Access Compliance Report

Public Rights-of-Way

Intersection ID: 29604	Main Street: CAMDEN_CREEK_LN	Cross Street: SANDY_PORTER_RD	Location: N
ADA ID: E2D3B95D4E3F	Ramp Type: PerpDiag	Initial Pass/Fail: Fail	Overall Compliance: No
Severity Score: 31.25			
Codes/Mitigation Info/Possible Solution		Field Measurements/Component Compliance

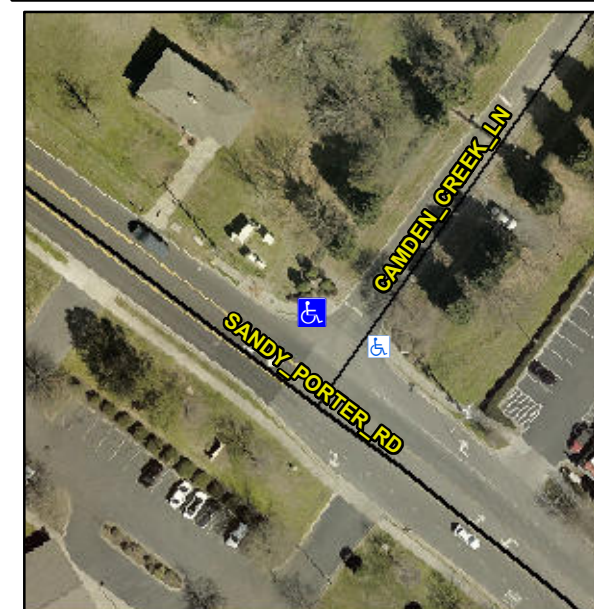
Not Found, R304.5.1, R304.2.2, R304.5.3

Compliance	Description	Data	Compliance	Description	Data
N/A	Ramp Length (in)	71.0	No	Ramp Slope (%)	9.2
No	Ramp Width (in)	34.5	No	Ramp XSlope (%)	2.1
N/A	Flare Type LT	N/A	N/A	Flare Type RT	N/A
N/A	Flare Slope LT (%)	N/A	N/A	Flare Slope RT (%)	N/A
N/A	Flare Traversable LT?	N/A	N/A	Flare Traversable RT?	N/A
N/A	Landing Length (in)	N/A	N/A	DWS Provided?	N/A
N/A	Landing Width (in)	N/A	N/A	DWS Contrast?	N/A
N/A	Landing Slope (%)	N/A	N/A	DWS Length (in)	N/A
N/A	Landing X Slope (%)	N/A	N/A	DWS Full Width?	N/A
N/A	Landing Curb? (Y/N)	N/A	N/A	DWS Offset (in)	N/A
N/A	Shared Landing?	N/A			
N/A	Gutter Ponding?	N/A	N/A	Gutter Slope (%)	N/A
N/A	Gutter Lip Ht (in)	N/A	N/A	Gutter X Slope (%)	N/A
N/A	Painted X Walk1?	No	N/A	Painted X Walk2?	No
	X Walk 1 Direction	To SW		X Walk 2 Direction	To SE
N/A	X Walk 1 Width (in)	N/A	N/A	X Walk 2 Width (in)	N/A
	X Walk 1 Slope (%)	4.1		X Walk 2 Slope (%)	0.4
	X Walk 1 X Slope (%)	2.7		X Walk 2 X Slope (%)	2.3

Remove & Replace Curb Ramp With Two New Directional Ramps or Equivalent.
